Technical Memorandum

Background Uranium Concentration

Homestake Millsite, Grants New Mexico

Prepared by: Tom Myers PhD

Figure 15: Uranium concentrations for the HMC Middle Chinle non-mixing zone wells. Source of data: Homestake digital groundwater chemistry database

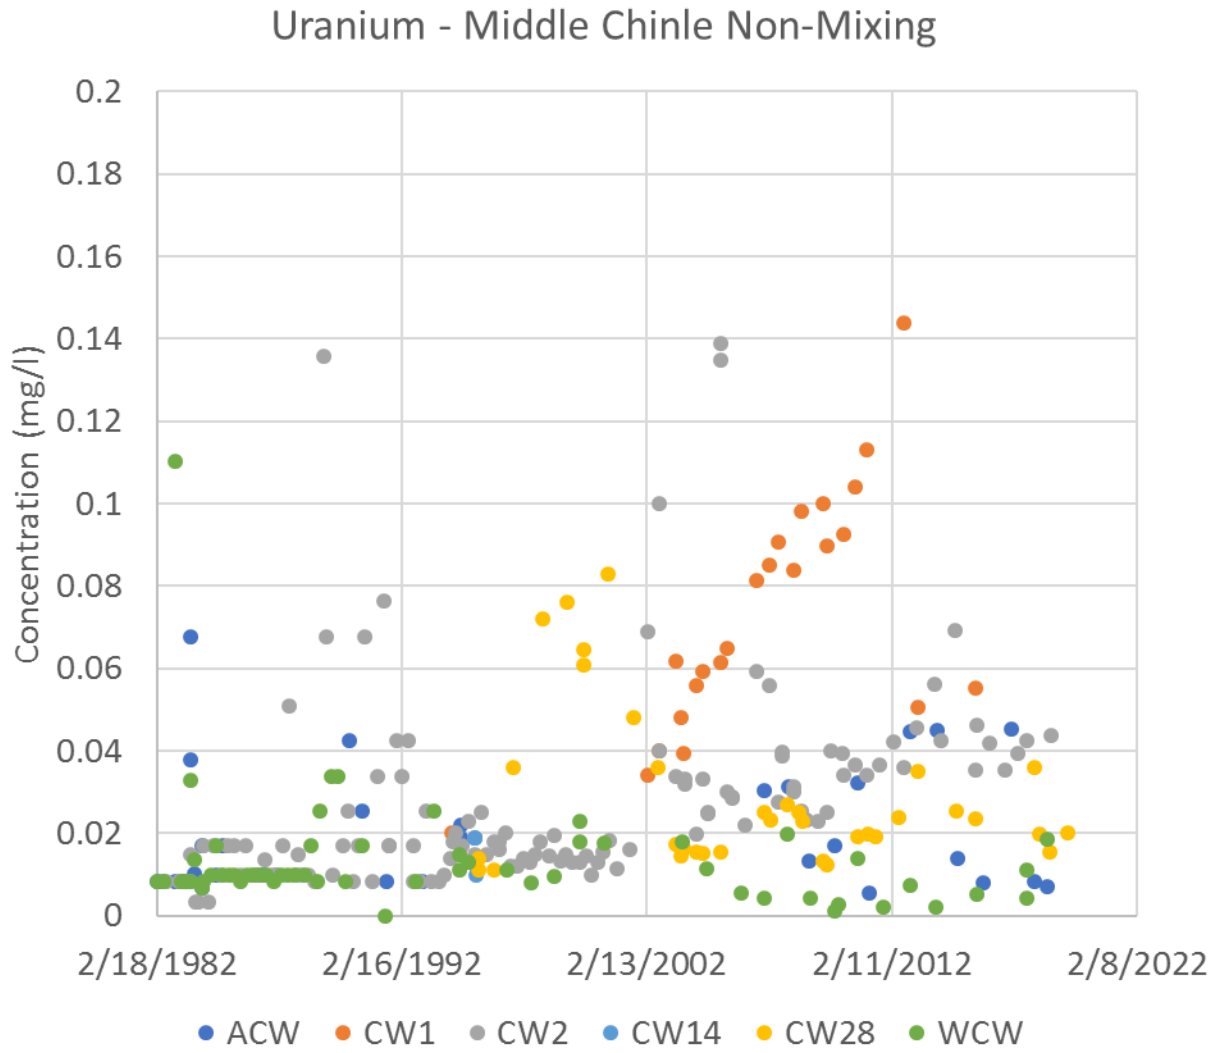
Most U concentrations at four Middle Chinle nonmixing wells south of the LTP are less than 0.05 mg/l (Figure 15). The exceptions are five observations at CW28 between 1997 and 2000 and one observation at ACW and WCW during 1982 and 1983. U concentrations at CW1 and CW2, which are just north of the LTP (Figure 14), trended up with time, showing a clear effect of leakage from the LTP which could have reached the Middle Chinle without passing through a mixing zone but by seeping through the Middle Fault (fault shown on Figure 2 but not on Figure 14).

Middle Chinle well data from 1982 through 2002, not including CW1 and CW2, has a 95% exceedance of about 0.068 mg/l. If the five anomalous data points at CW28 are removed, the 95% exceedance would be about 0.05 mg/l and if the 1982 and 1983 points are removed, it would be close to 0.04 mg/l. The median value is 0.01 mg/l due to many non-detects. Since 2002, all data other than from CW1 and CW2 are less than 0.035 mg/l excepting three data points at ACW which are a little higher than 0.04 mg/l. U concentrations in the Middle Chinle nonmixing zone have decreased with time which indicates that removing the anthropogenic source allows the aquifer to return to its natural background. This would not likely have occurred if natural factors worked to keep the U concentrations high.

A fair background level for the nonmixing zone Middle Chinle aquifer would be 0.04 mg/l, based on frequency analysis of HMC's Middle Chinle well data from 1982 through 2002 excepting wells and observations described above. It also accounts for the many Middle Chinle wells in the three subdivisions with very low concentrations early in the period by using a lower estimate even though the data is not amenable to being added to the frequency analysis. Using this data accounts for the fact that U concentrations are variable, but most were initially very low. Higher U in the Middle Chinle that occurred subsequent to low concentrations resulted from contamination in the alluvium and should not be considered background.

Figure 16: Uranium concentrations for the Middle Chinle mixing zone wells. Source of data: Homestake digital groundwater chemistry database

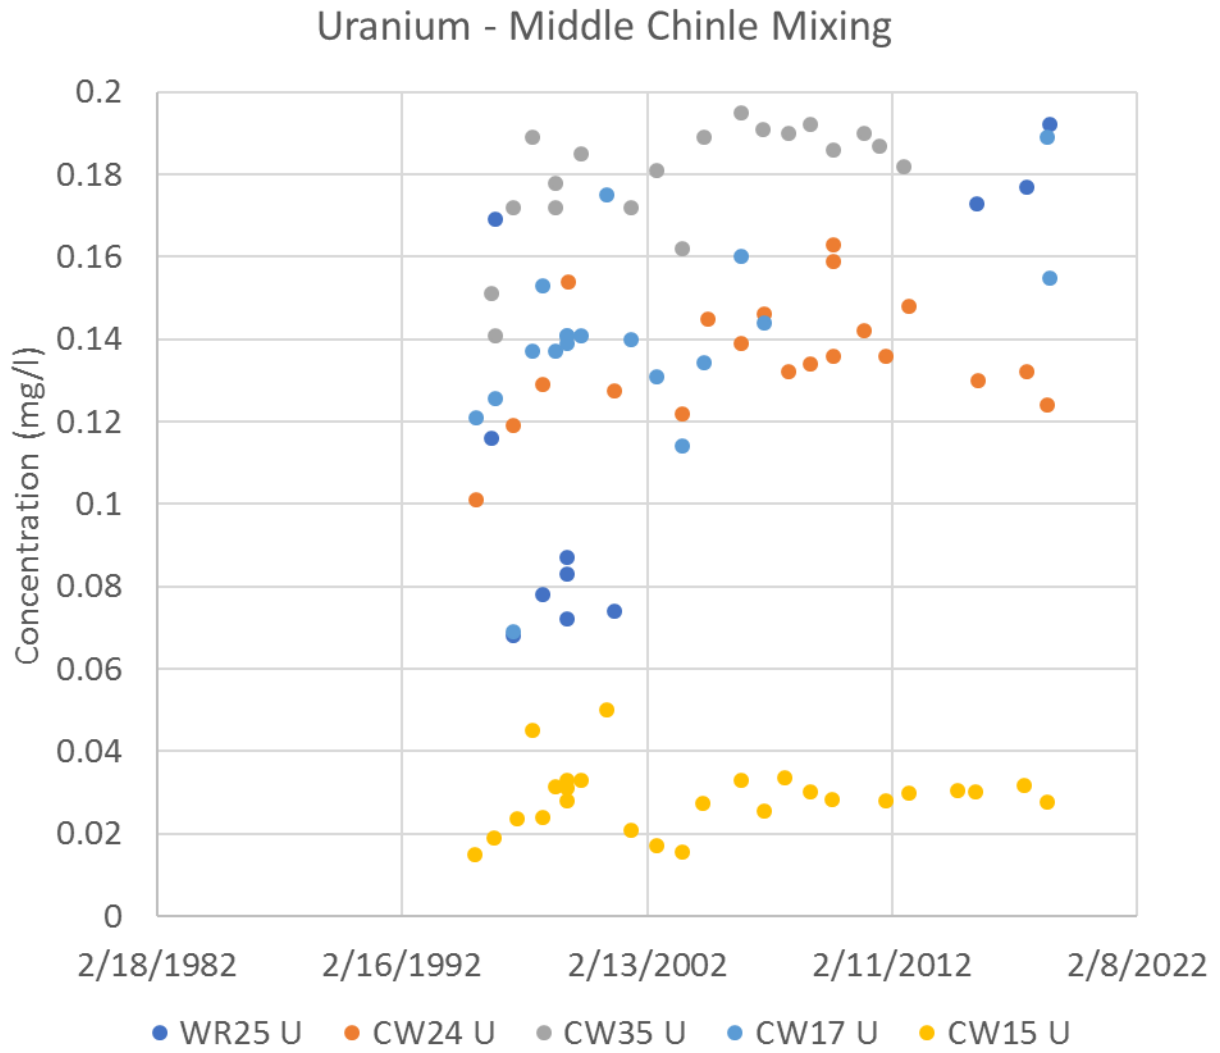
The Middle Chinle has two mixing zones, with one west of the West Fault and one near the subcrop at the southern boundary of the Middle Chinle between the faults. U concentrations at the four wells in the northern mixing zone, WR25, CW17, CW24 and CW35 (Figure 14), exceed 0.06 mg/l with no significant temporal trend (Figure 16). However, these data are more recent than 1992 which suggests that the same source affecting well DD in the alluvium could have affected these wells (Figure 4). All but two observations at mixing zone well CW15 in the southern mixing zone are less than 0.04 mg/l and the two exceptions are less than 0.05 mg/l (Figure 16). The alluvial aquifer over the southern mixing zone is not contaminated.

For the upper Chinle mixing zone, different wells are presented at different times rendering it difficult to determine trends (Figure 13). Overall, concentrations are generally less than 0.06 mg/l with the two wells that have data prior to 1990 being less than 0.04 mg/l. No trends are apparent except that data collected later in the period are higher than those collected earlier, but from different wells. Middle Chinle concentrations substantially exceeded 0.05 mg/l with three exceeding 0.10 mg/l at four of the

five wells which also range to almost 0.2 mg/l with no trend from 1992 (Figure 16). The four wells with high concentrations are just west of the LTP near the West Fault (which now may be considered closer to the LTP than it was previously) in the high U flow path (Figure 4). The fault has been considered a pathway to the Chinle and the data confirm that hypothesis. Concentrations for the lower Chinle tend to be less than 0.04 mg/l, with some upward trend starting about 2003 (after the background period and possibly due to flushing at the LTP (HMC 2019)) at CW43 to greater than 0.05 mg/l; this could easily be linked to the earlier high U concentrations in the alluvium near the lower Chinle subcrop.

Figure 20: Uranium concentrations for the Lower Chinle non-mixing zone wells. Source of data: Homestake digital groundwater chemistry database

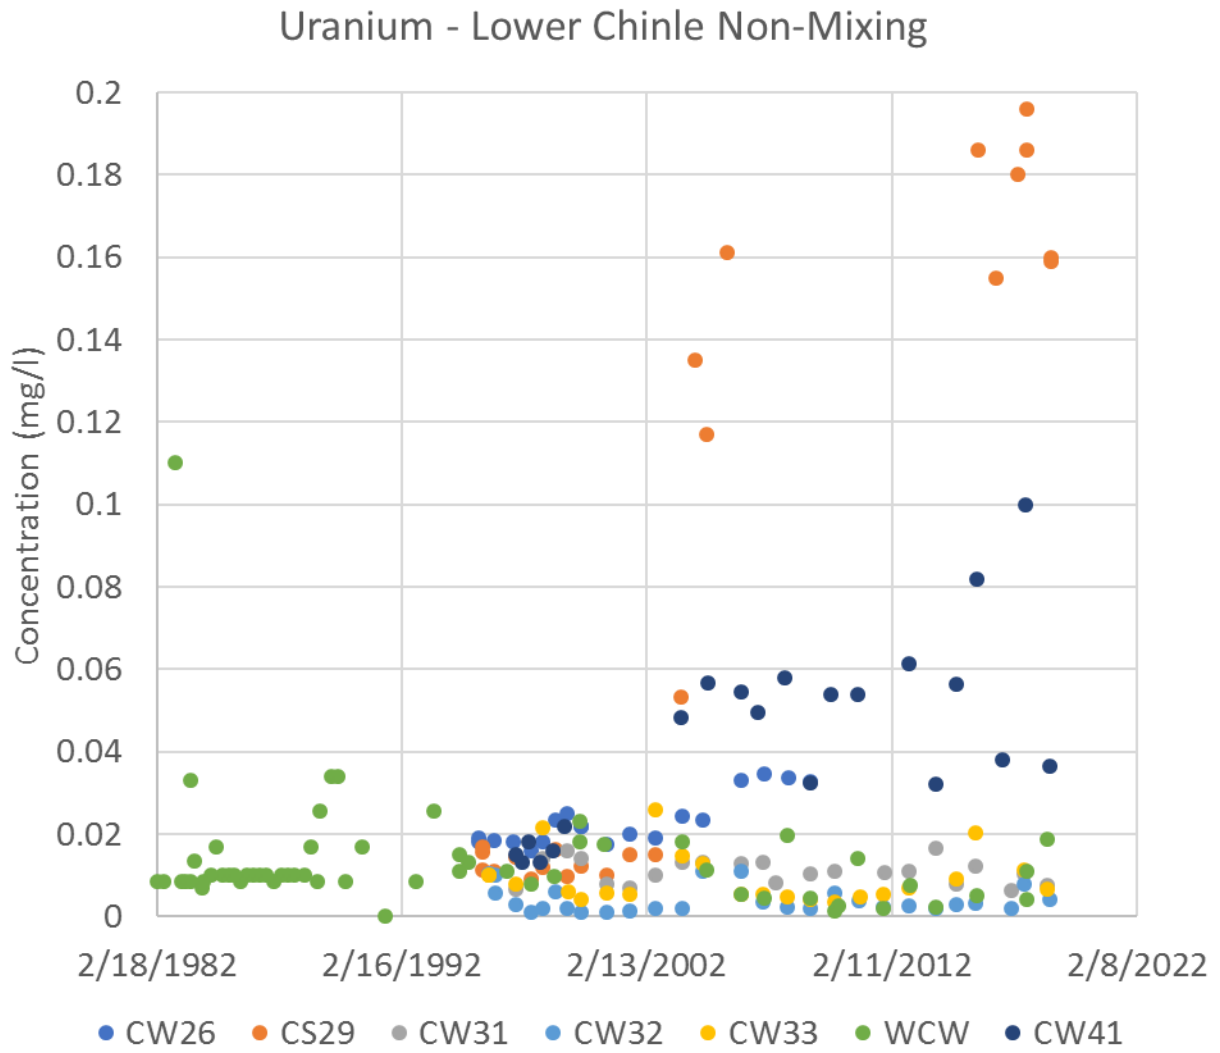
HMC based the background determination for Lower Chinle nonmixing zone on data from 1995 through July 2002. HMC recommended background equal to 0.03 mg/l, with the 95% exceedance equaling 0.02 mg/l (HMC 2015) (Figure 20). Prior to 1995, a few observations slightly exceeded 0.03 mg/l at WCW. Beginning in July 2002, a significant increase commenced with the U concentration in CW29 almost reaching 0.2 mg/l. The mixing zone primarily has concentrations less than 0.03 mg/l, but in well CW43 the concentrations have increased to exceed 0.04 mg/l. Well CW43 is nearest the subcrop over which U concentrations have begun to increase west of the LTP in the paleochannel. Wells CW29 and CW41 are southwest of Felice Acres. Because there are no monitoring wells in the mixing zone south of the wells, it is not possible to track the potential movement of U to these wells from the subcrop. The contamination could result from movement through the East or Middle Faults.

HMC's recommended 0.03 mg/l background is appropriate for the Lower Chinle nonmixing zone.

Figure 22: Percent exceedance plot for Chinle mixing zone wells not affected by millsite contamination, from 1987 through 2018. Includes wells CW9, CW10, CW50, CS52, CW36, CW37, CW39, and CW15. One observation is off the chart at 0.3 mg/l. Data source: HMC database

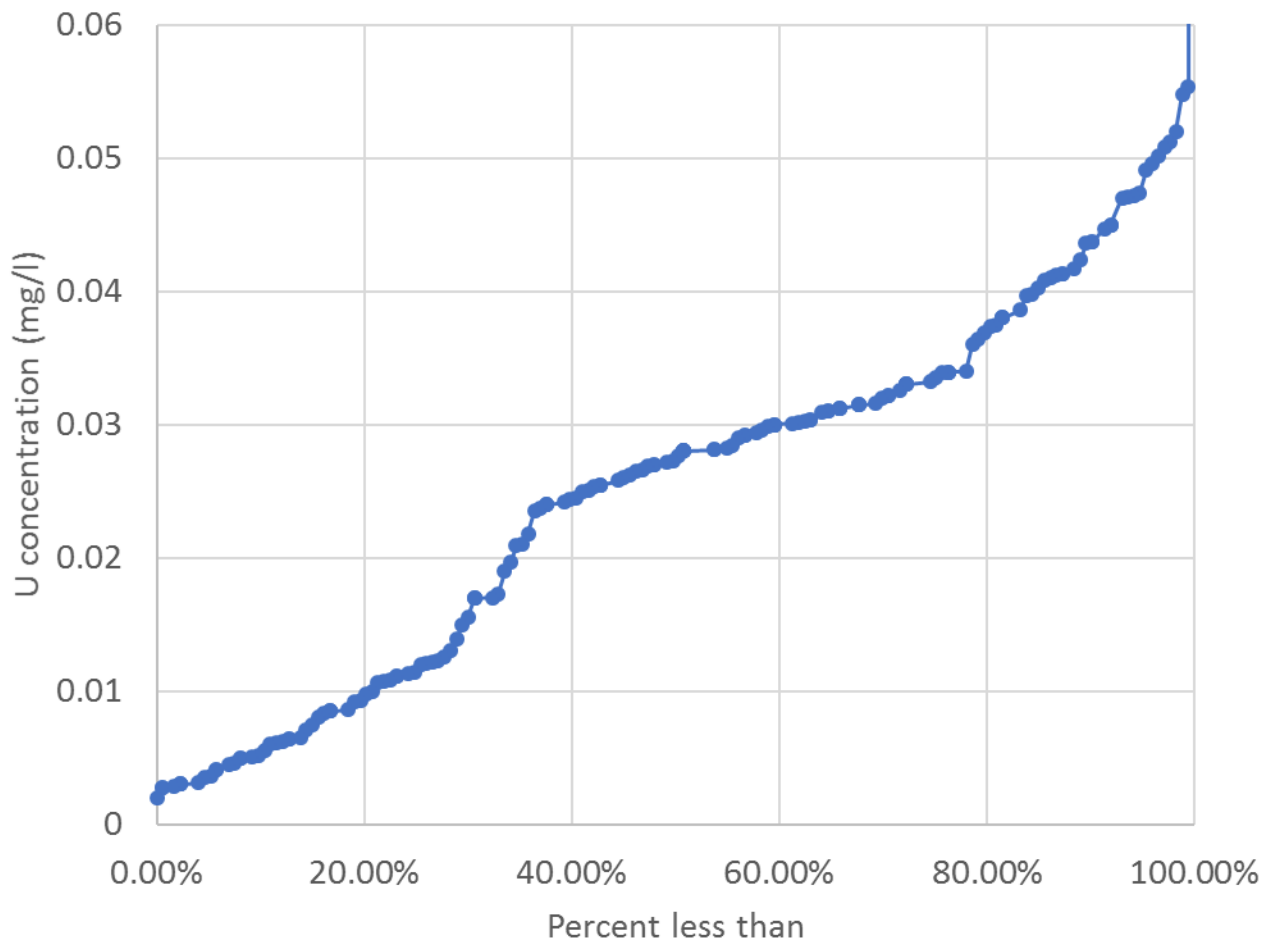
As described, HMC grossly overestimated the background concentrations for the Chinle mixing zones because it included impacted Middle Chinle mixing zone wells. Most U concentrations in the Upper and Lower Chinle mixing zones are less than 0.05 mg/l, the high values in the Middle Chinle mixing zone controls HMC's estimated background. All HMC data from the Upper and Lower Chinle mixing zone and Middle Chinle well CW15 through 2018 are appropriate to consider for background. Extending the data through the present for unaffected wells is appropriate due to the lack of trends. The 95% exceedance is 0.048 mg/l, with the median being 0.0275 mg/l (Figure 22). A fair background level for the Chinle mixing zones is 0.05 mg/l, not the 0.18 mg/l as proposed by HMC. The primary difference is to not consider the Middle Chinle mixing zone wells under the high-U pathway west of the LTP. It is appropriate that the mixing zone has a higher background than the alluvium because it is possible the water attains some U passing into the Chinle.
